**APPEAL BY READING AND WEST ARCHITECTS ON BEHALF OF RON NEUMUNZ
AGAINST THE ROYAL BOROUGH OF KENSINGTON AND CHELSEA'S DECISION
DATED 17TH MAY 2001 TO REFUSE PLANNING PERMISSION FOR THE ERECTION
OF A MANSARD ROOF ADDITION AT 24 CAMPDEN HILL GARDENS, LONDON, W8.**

Planning Inspectorate Reference: APP/K5600/A/01/1077702

RESPONSE TO THE COUNCIL'S STATEMENT OF CASE UNDER RULE 6

Against a decision of the Royal Borough of Kensington and Chelsea
dated 17 May 2001
to refuse to grant planning permission for a mansard roof
extension at 24 Campden Hill Gardens, London W8

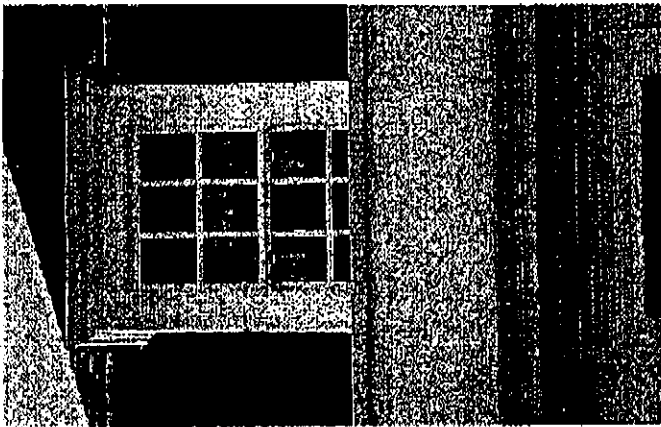
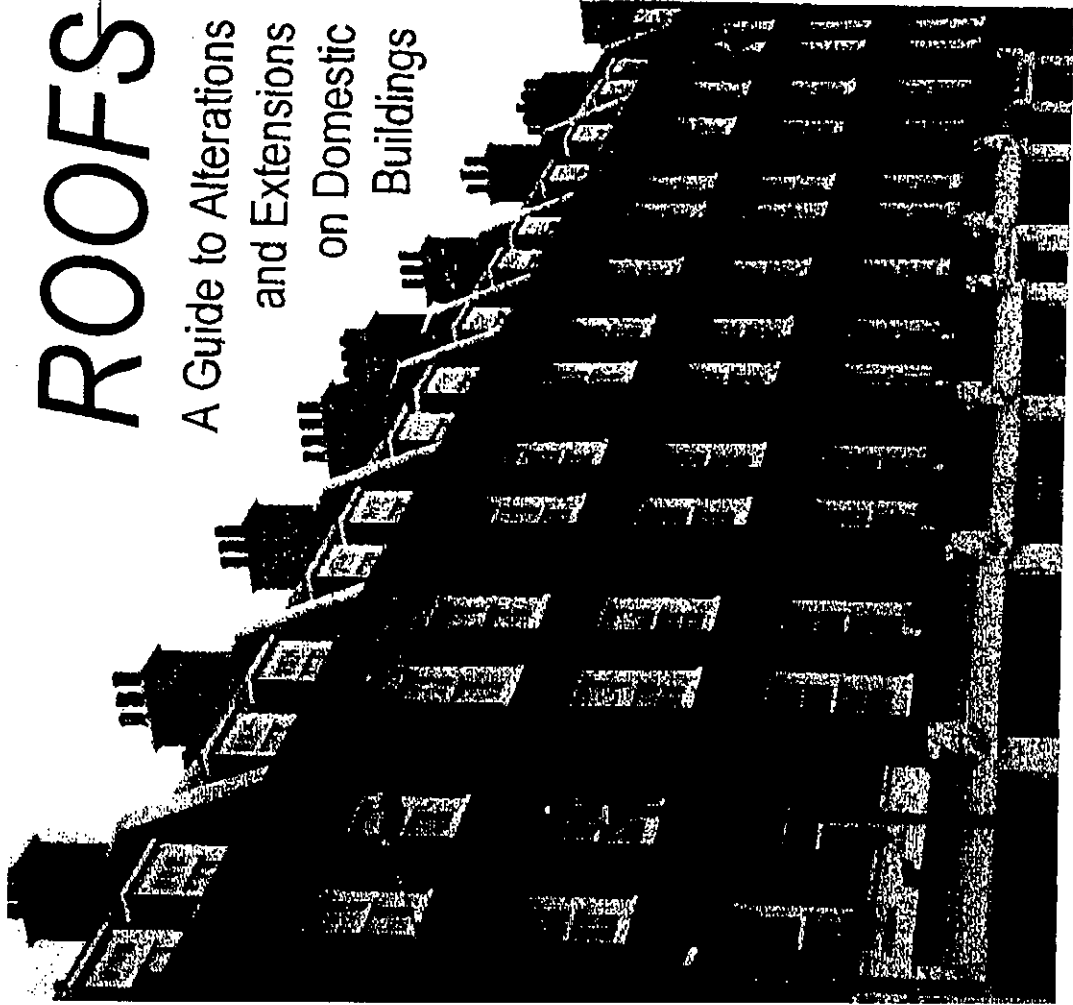
?

But they are claiming a precedent from opp side of road!
